2NSW-105 (sheet 2 of 2)
Upper Containment Ventilation
Unit 3 Supply Line

POUR/ZONE No. 115	FLOW DIAGRAM 2-SH-4A
REQUIRED COMPLETION DATE	Q.S.L. SEE DESIGN
FABRICATED BY TUBECO	WELD PROCEDURE CODE STAMP
NPS DESIGNS INC. NEW YORK, N.Y.	LIVSEY & COMPANY, INC. INDIANA & MICHIGAN ELECTRIC CO. DONALD C. COOK NUCLEAR PLANT
FABRICATOR NOTE: FABRICATION MUST CONFORM TO LATEST A.E.P. ARRGT. DWGS.	DWN: SSG DATE: 6/24/76 CKD: GN DATE: 6/72 ISSUED
	DWG. NO. 2-NSW-105 SH. 2 OF 2
	REV. 8

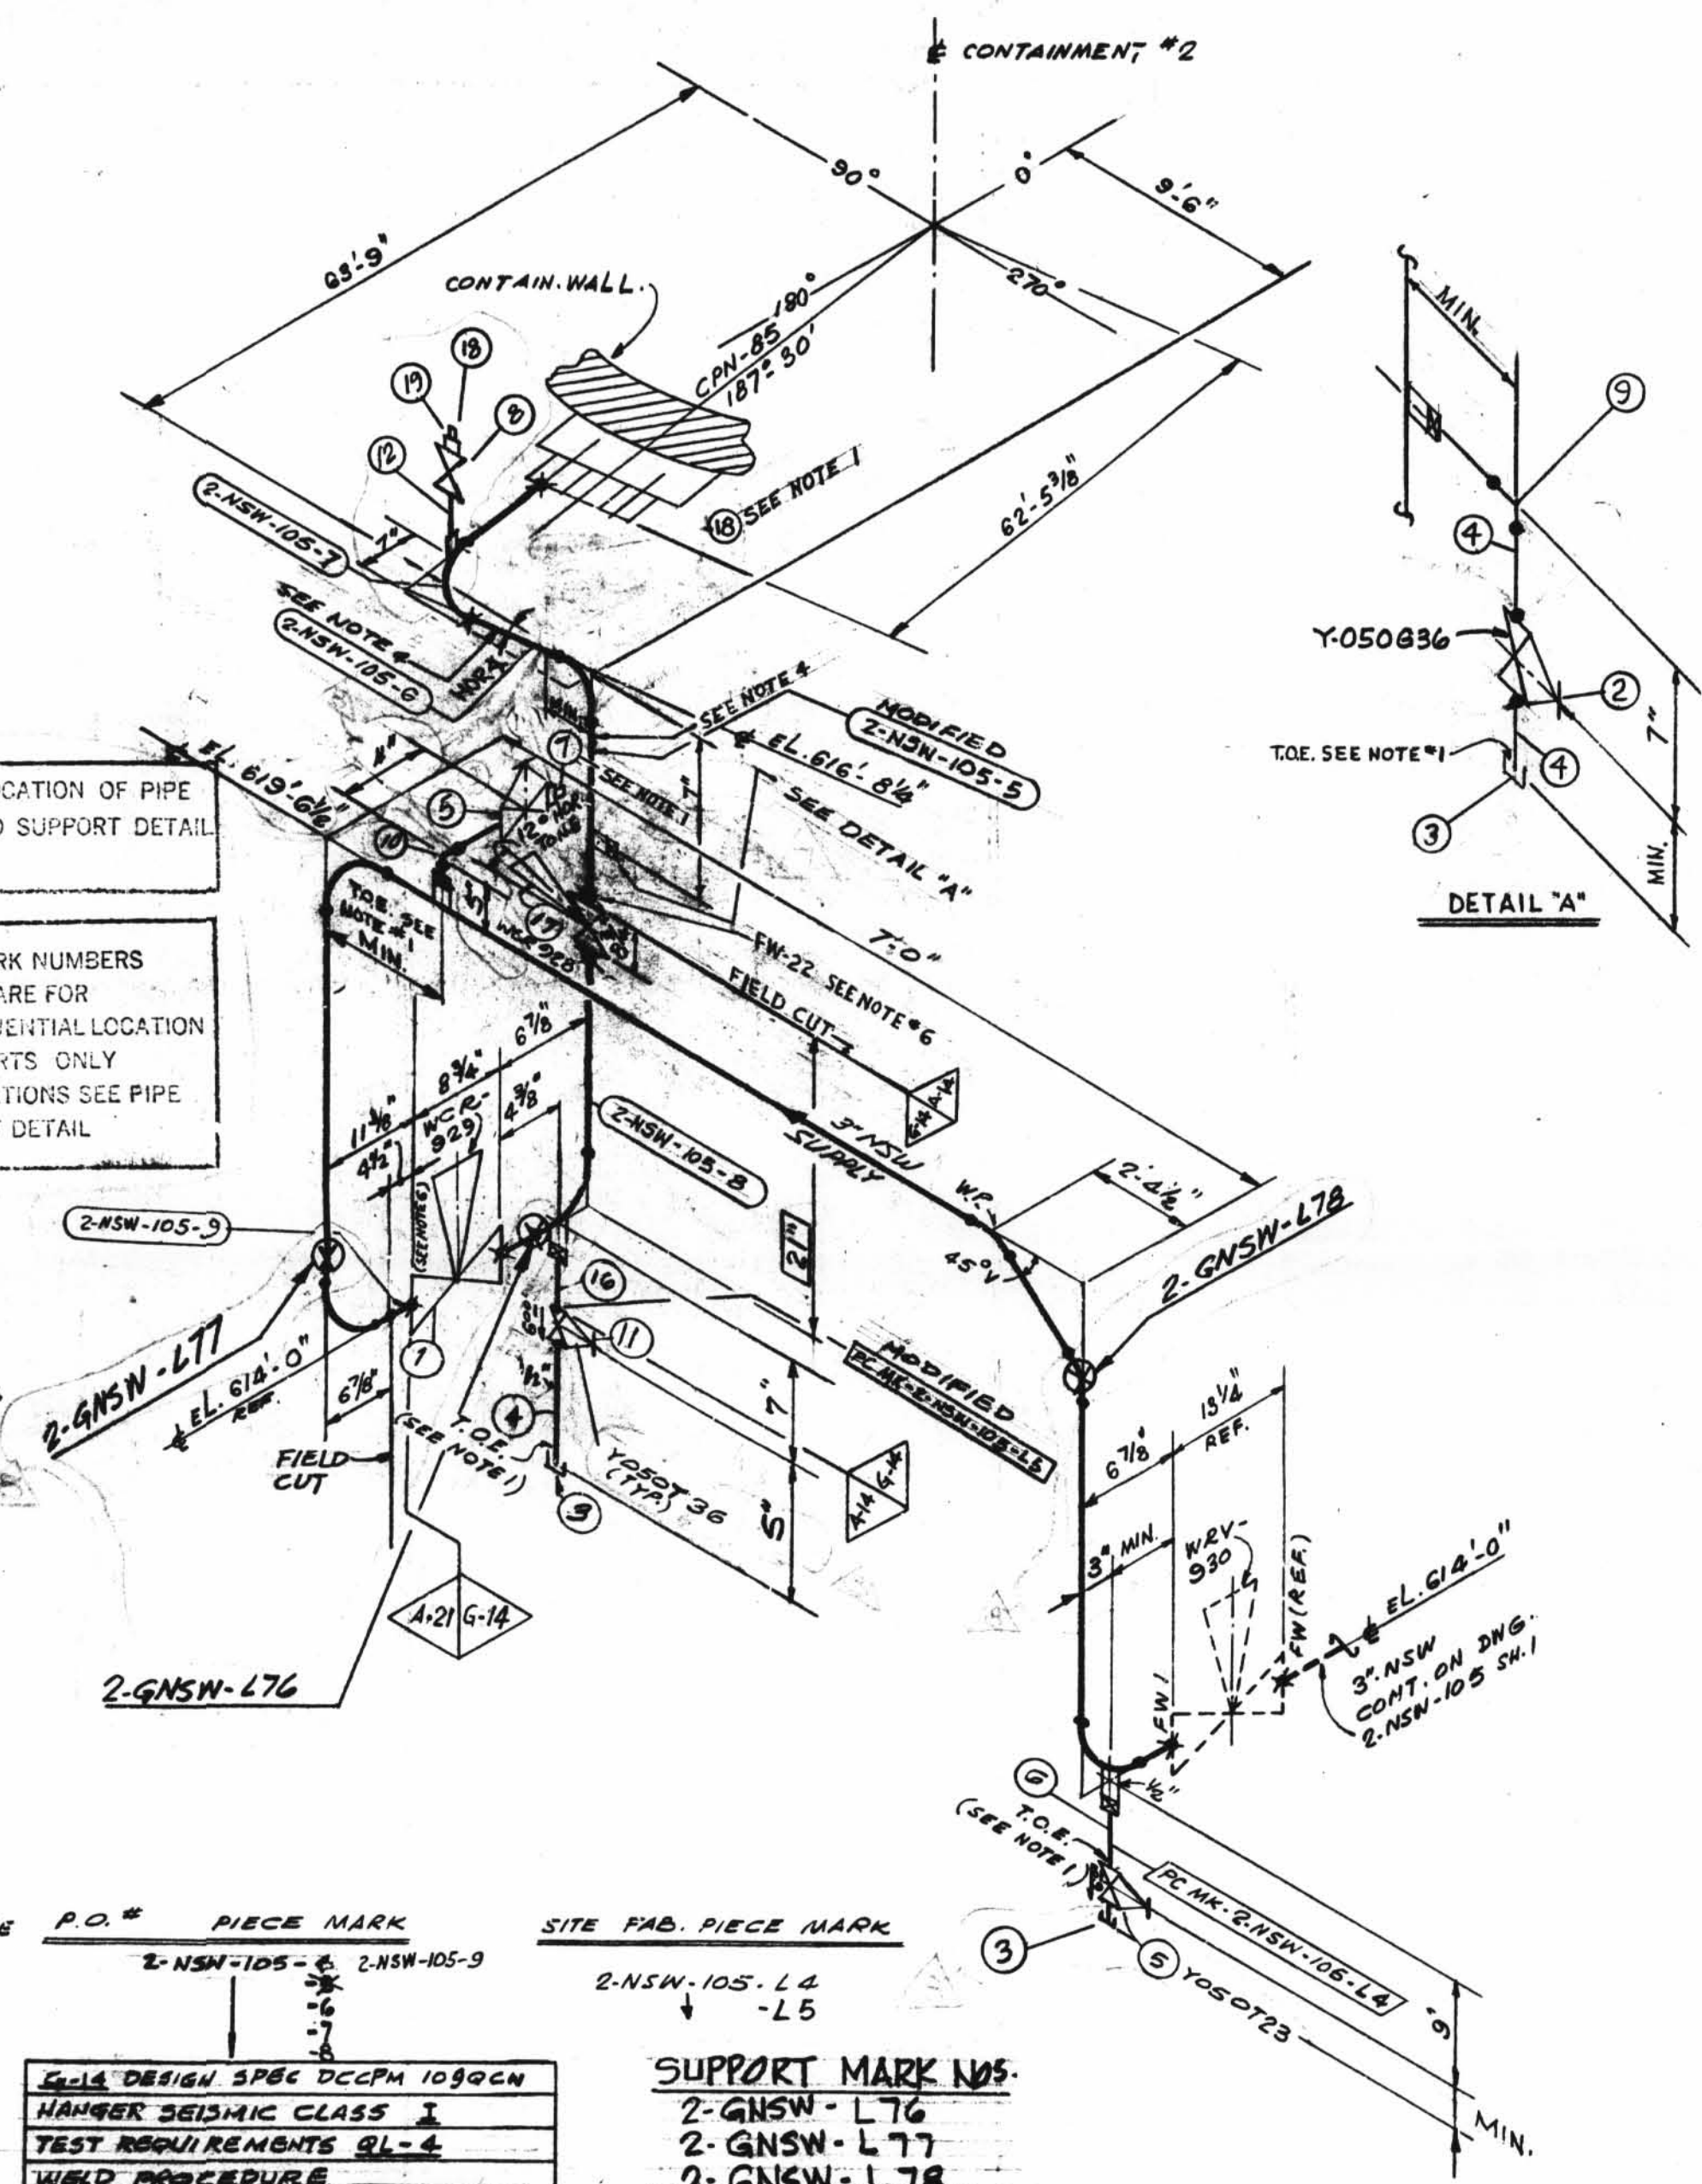
REVISION RECORD			
NO.	DATE	DESCRIPTION	REMARKS
1	7/10/76	REVISED BY AEP DESIGN PER RFC-12-671; REV'D; ITEM #2 Y-050G36 WAS CY-050G36 ADDED; 3" CHECK VALVE CISC03A, (2) 1" VENTS - VALVE NO Y-100T23, 1/2" DRAIN VALVE NO Y-050G36	ACTION REQ'D
2	7/23/76	ADDED: ITEMS 9, 10 & 11 TO E/M.	
3	8/1/76	AS PER RFC-12-1790 DELETED VALVE TAG NO. CISC03A, ADDED VALVE TAG NO. CISC03A & ITEMS 12 THRU 15 AND REVISED DIMENSIONS	FIELD ACTION REQ'D
4	7/14/76	PER RFC DC-12-2549 ADDED PIPE SPEC. G-14, DIM'S, PC MK, 845, FIELD WELD 100%. NOTES G & 7, FW 12 TO 23. FSW 24 & 25 ITEMS 16 & 17 TO DIM. DELETED ITEMS 7, 12 TO 15 FROM E/M. REVISED ITEM NO. 1 IN DIM. MODIFIED, PCMK, LS, 2-NSW-105-5.	FIELD ACTION REQ'D
5	7/14/76	PER RFC DC-12-2549 ROTATED ACTUATOR OF VALVE WCR-928 TO 12" HOR. TOWARD NORTH-EAST, REVISED ITEM 3 IN E/M; Y-050T36 WAS Y-050T23	FIELD ACTION REQ'D
6	7/14/76	PER RFC DC-12-2548 RELOCATED TEST CONN. BOXED DIMENSION INDICATES FIELD INFO. ADDED PLUG TO ITEM 8 & 9M.	FIELD ACTION REQ'D

7	7/14/76	PER RFC DC-12-2545 ADDED RED. INSERT, ITEM 19, & PLUG, ITEM 18, TO VALVE, ITEM 8. ITEM 8 WAS Y-100T23 & ITEM 18 WAS 1"	NO ACTION REQ'D
8	7/12/76	TO REFLECT AS-FOUND CONDITIONS FOR RFC DC-12-3010 PER FWR#759 REV. 1; ADDED; DIMS. REVISED; LOCATION OF 1" VENT, 1/2" DRAIN FROM PLUG TO CAP & B/M TO SUIT. ADDED; SUPPORT MARK NOS. 8 SUPERSEDES HGR. 150. NO. 2-GNSW-105 SH. # 2.	NO FIELD ACTION REQ'D
